ADDENDUM NO. 1

DATE: March 27, 2020

FROM: Baxter & Woodman, Inc., Consulting Engineers

VILLAGE OF HOFFMAN ESTATES, ILLINOIS  
CHIPPENDALE LIFT STATION REHABILITATION

**M-1**

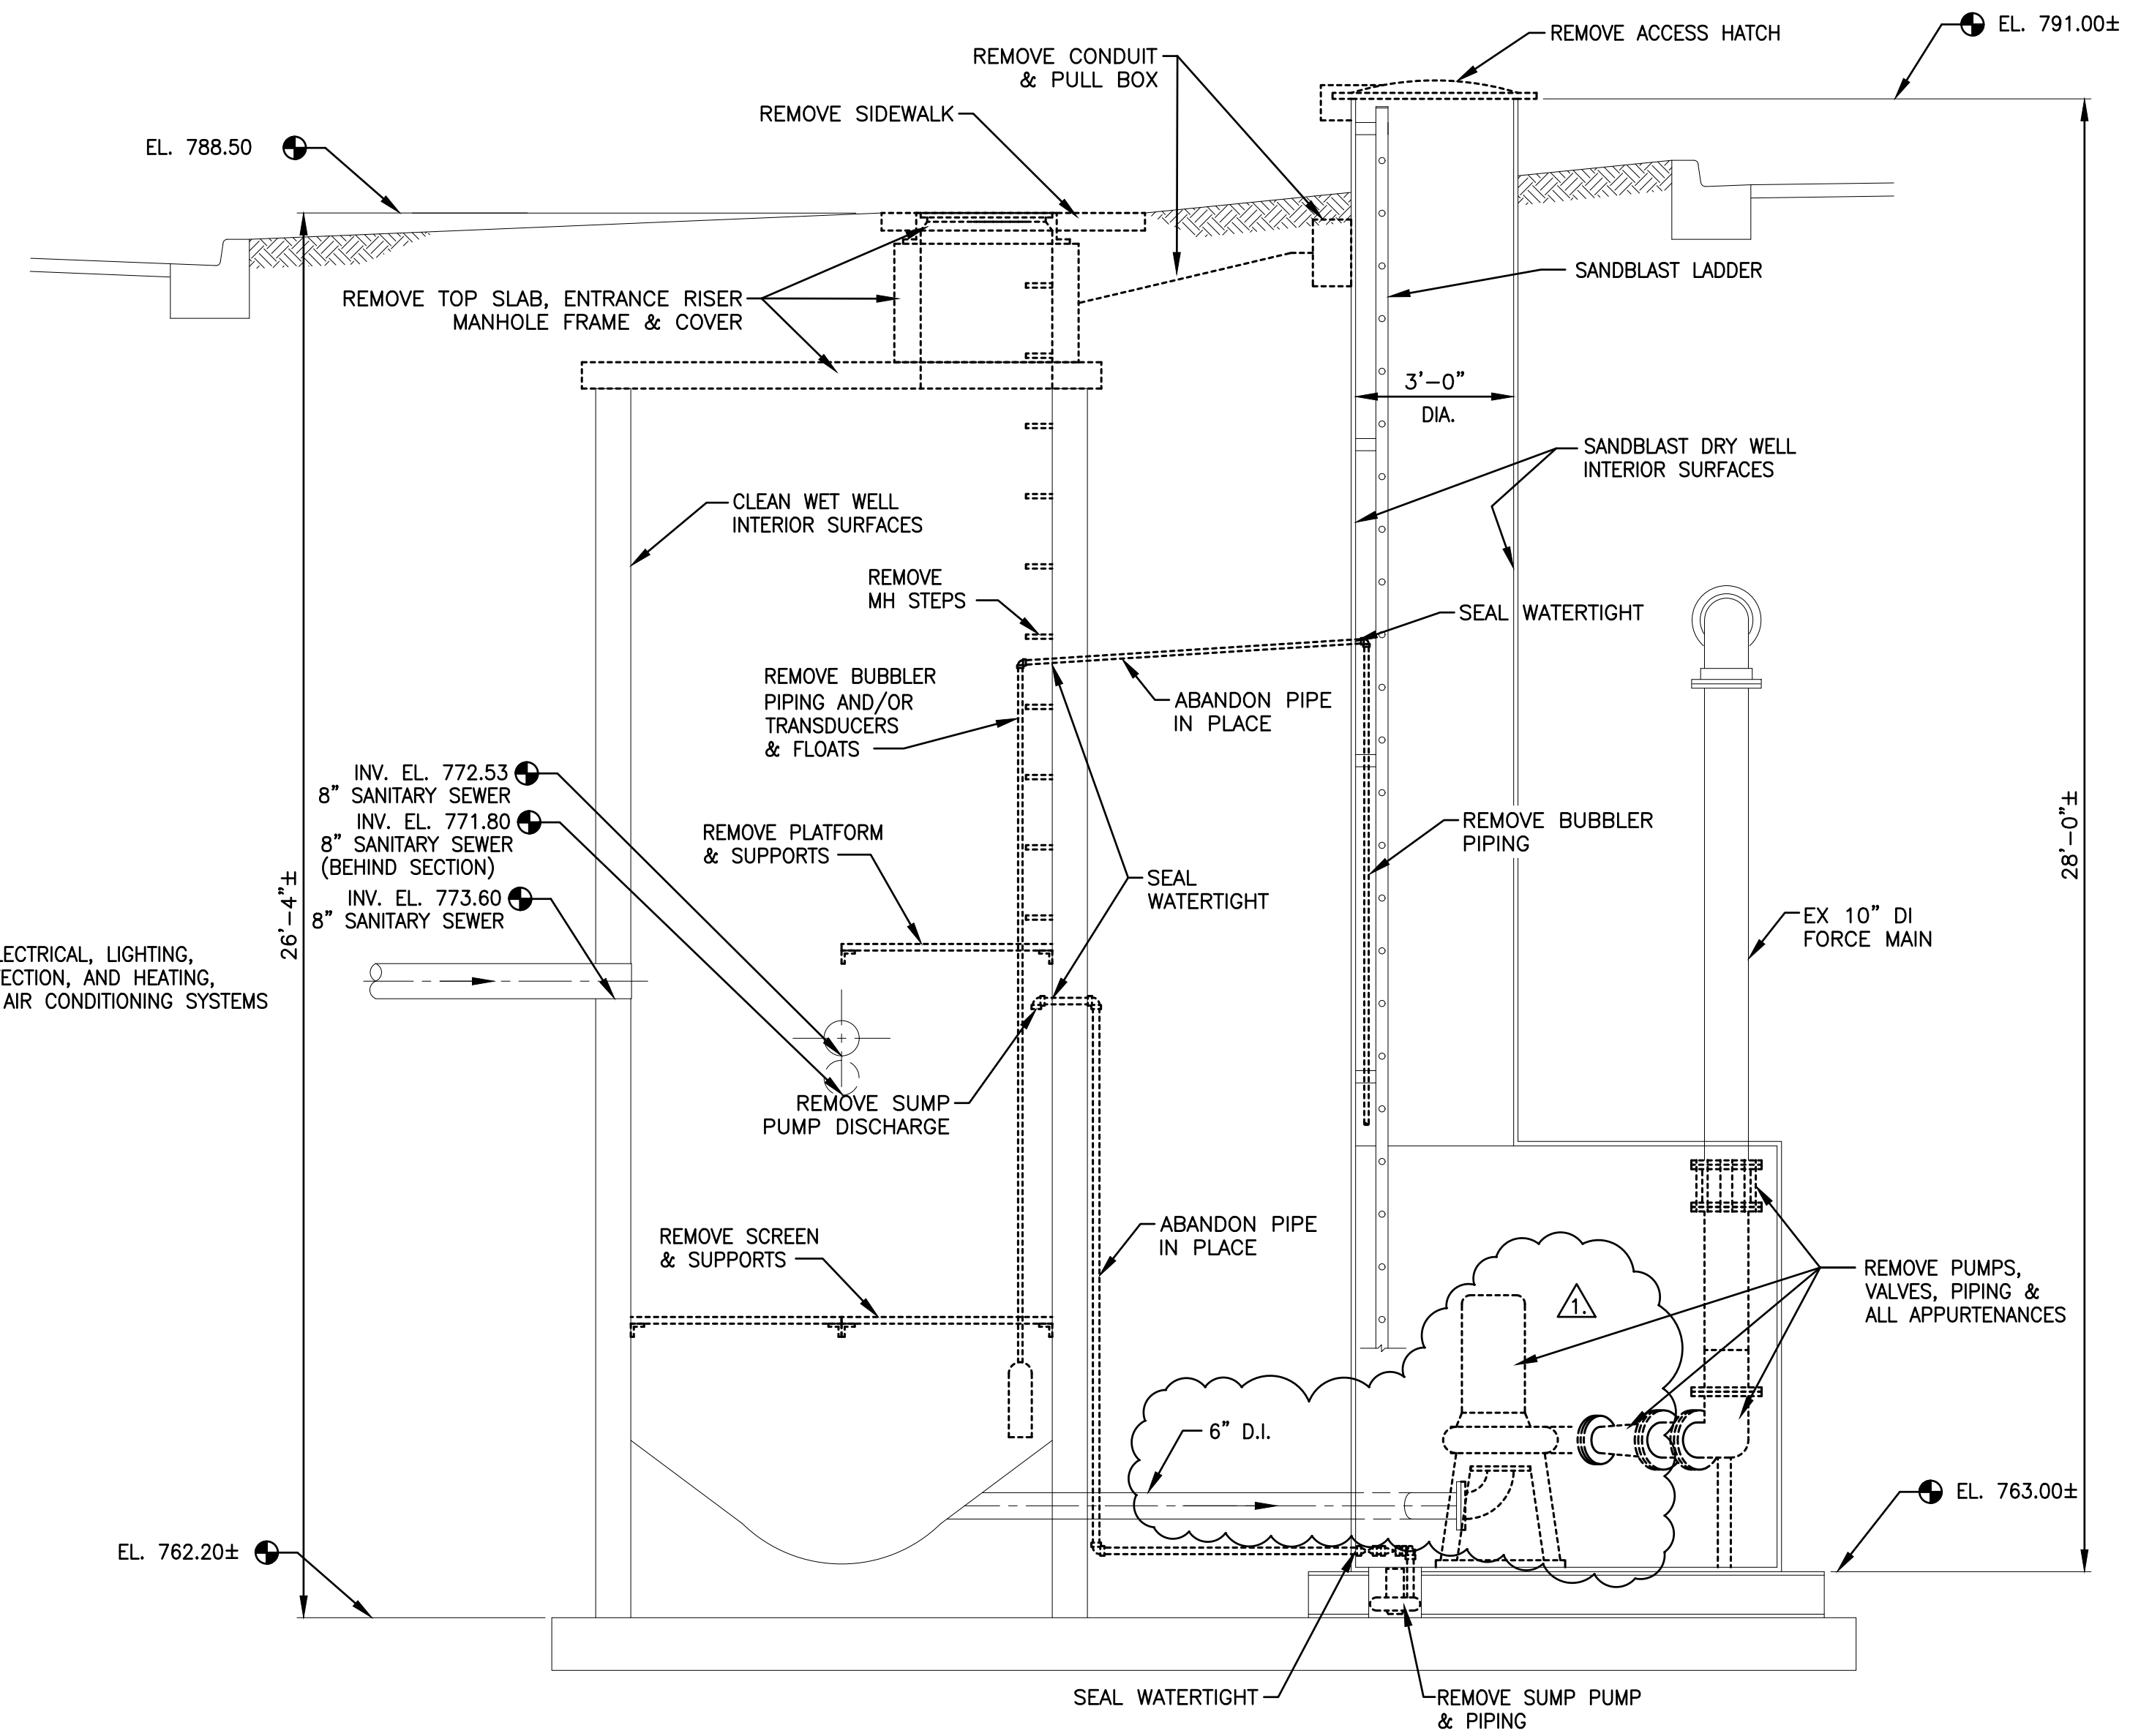
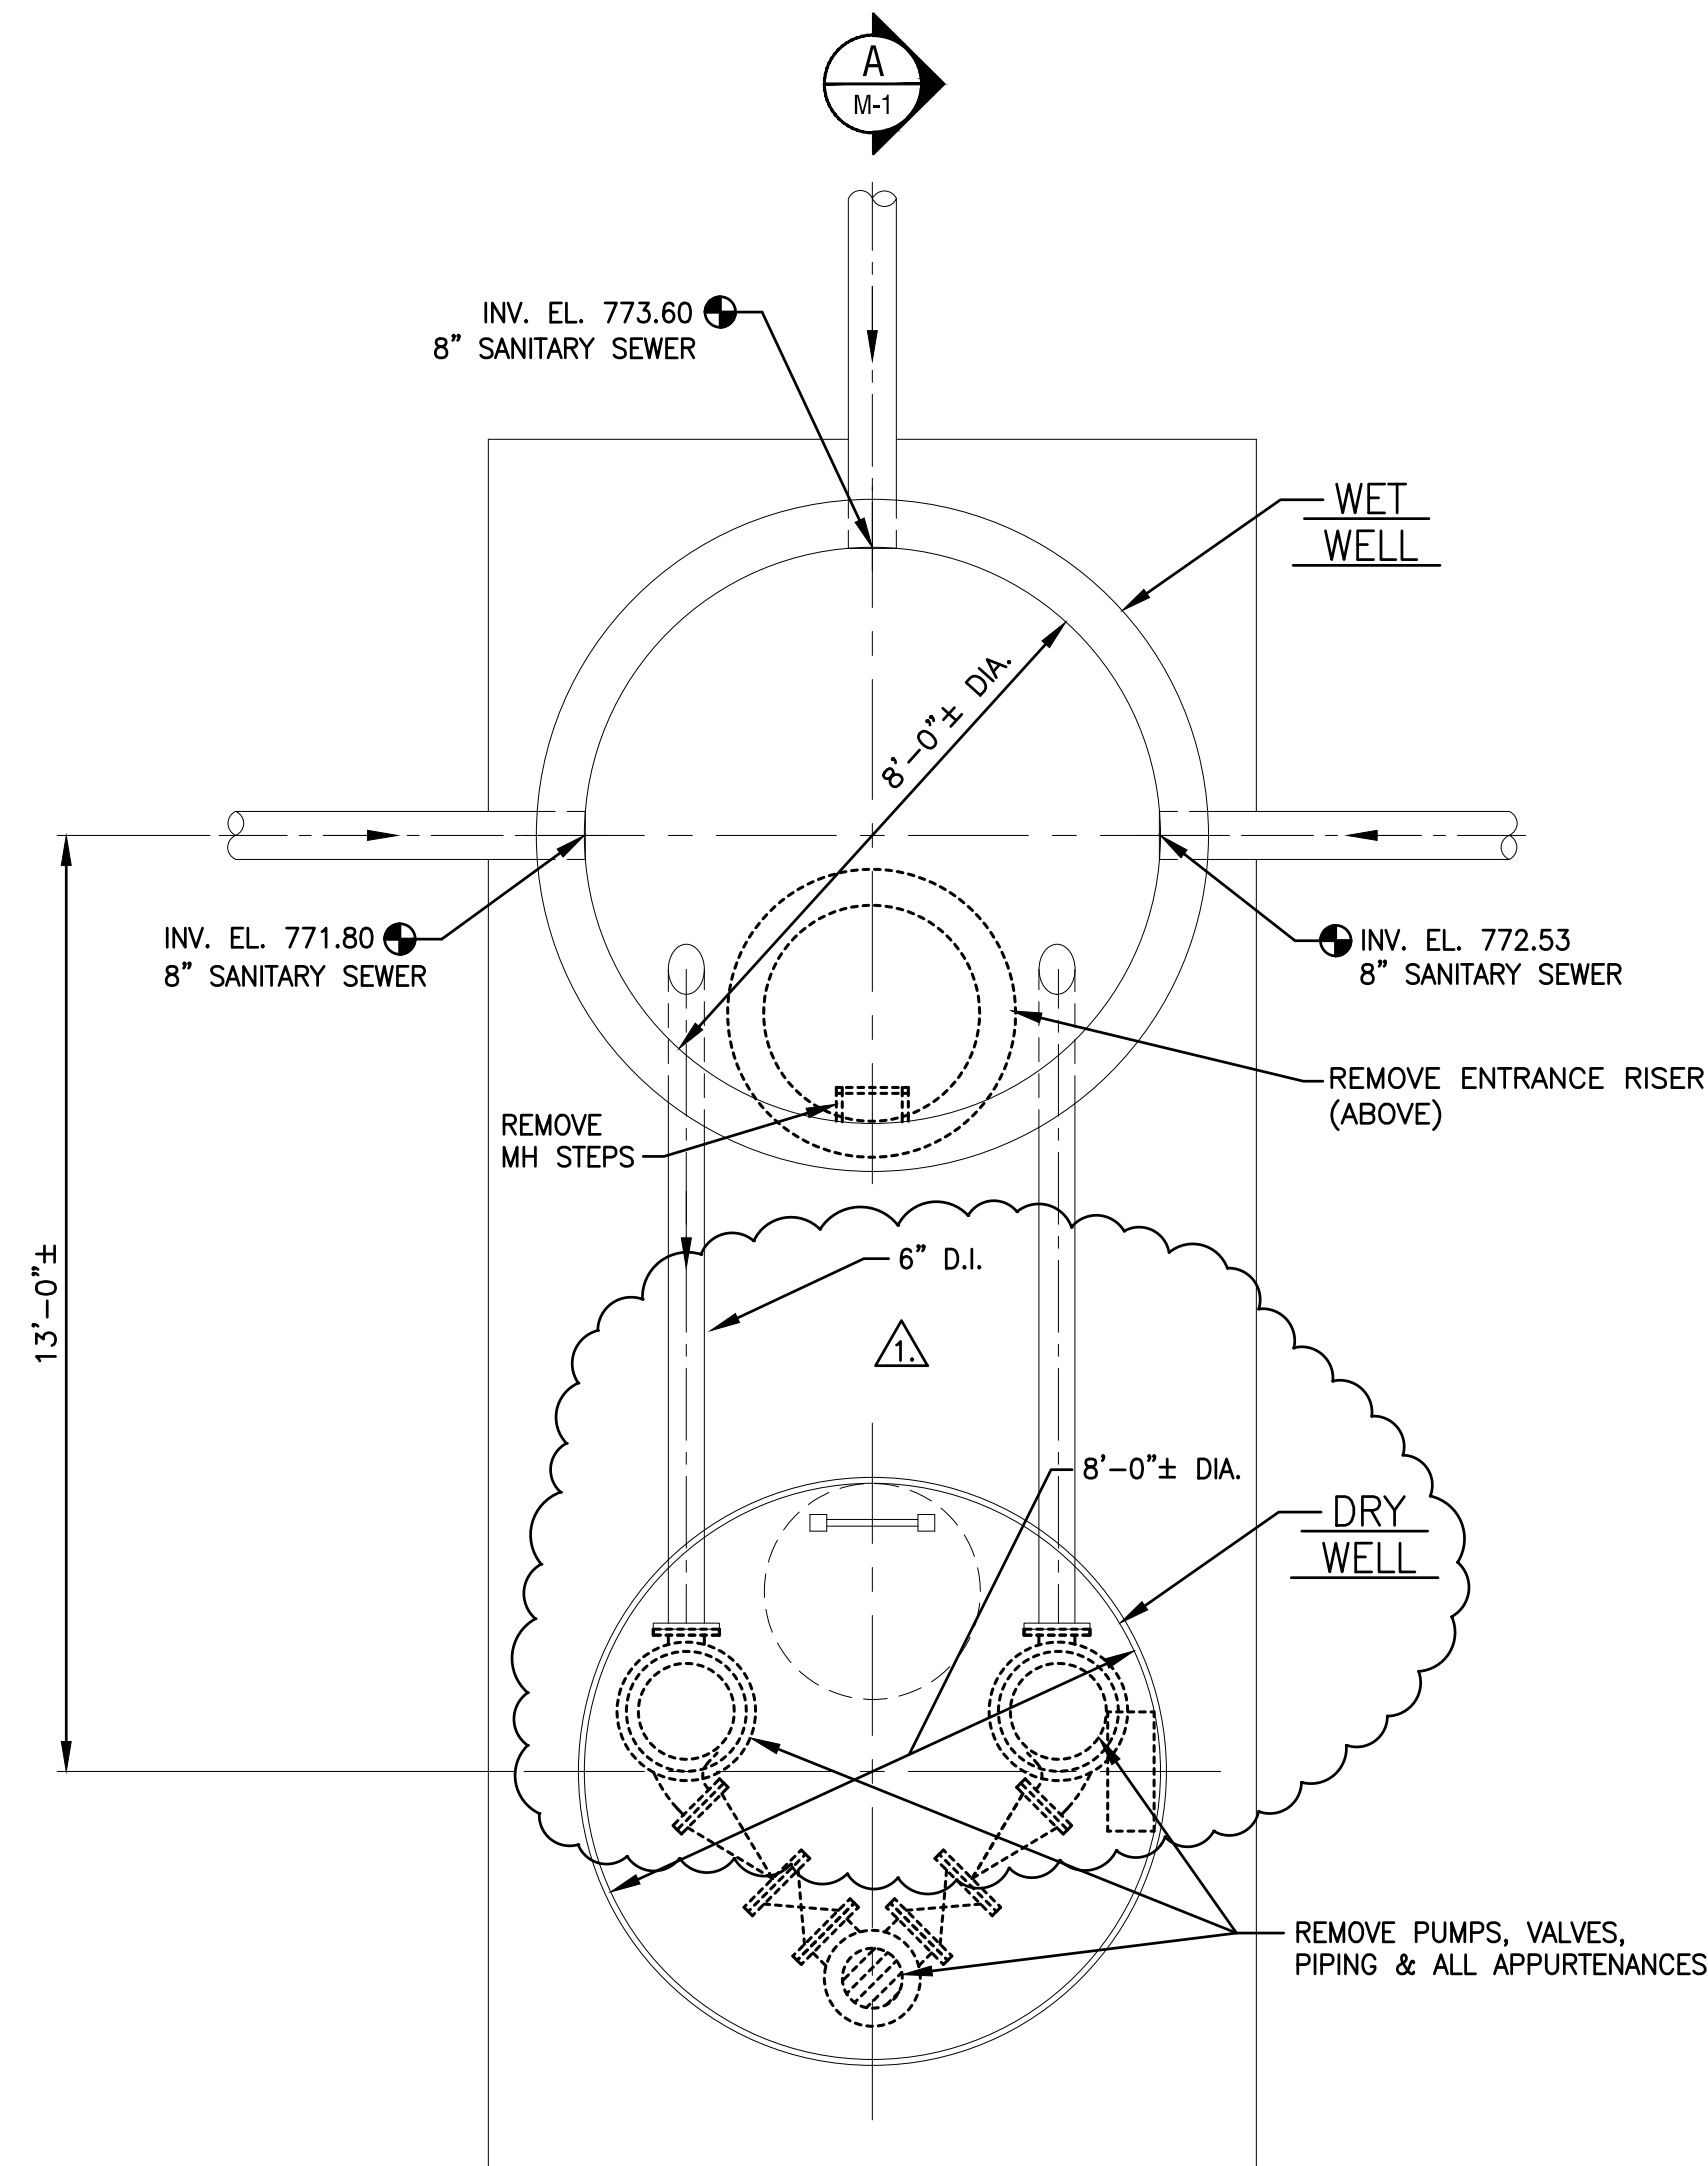
- C. Delete Sheets M-1 and M-2 in their entirety, and insert attached Sheets M-1 and M-2, revision dated March 26, 2020 in lieu thereof.

Piping and pump layouts for the existing (demolition) drawing and for the proposed pumps, piping, valves, and fittings drawing have been revised. In addition, the Notes on Sheet M-2 were revised.
